[Docket No. FAA-2020-1120; Project Identifier 2019-SW-056-AD; Amendment 39-21962; AD 2022-05-10]

Airworthiness Directives; Goodrich Externally-Mounted Hoist Assemblies

ACTION: Final rule.

Figure 4 to Paragraph (g)(2)(iv)

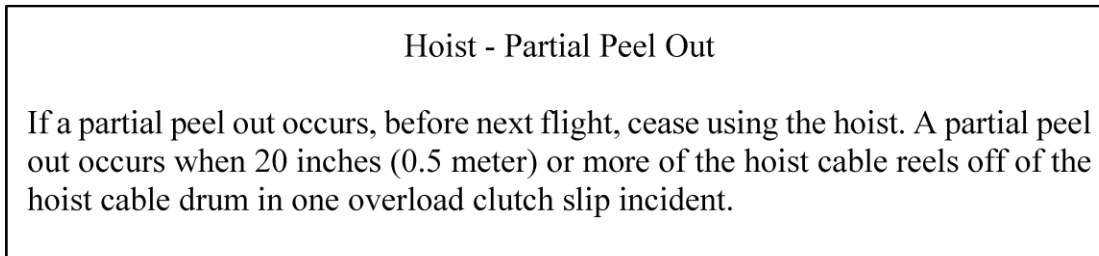
(iv) For 500 and 600 lb rated hoists, install a placard with the information in Figure 4 to paragraph (g)(2)(iv) of this AD in full view of the pilot and add the

information in Figure 4 to paragraph (g)(2)(iv) of this AD to the existing RFM for your helicopter.

(3) For all hoists identified in the introductory text of paragraph (c) of this AD, as of the effective date of this AD, if a partial peel out occurs, deactivate or remove the hoist from service before further flight. For purposes of this AD, a partial peel out occurs when 20 inches (0.5 meter) or more of the hoist cable reels off of the hoist cable drum in one overload clutch slip incident.
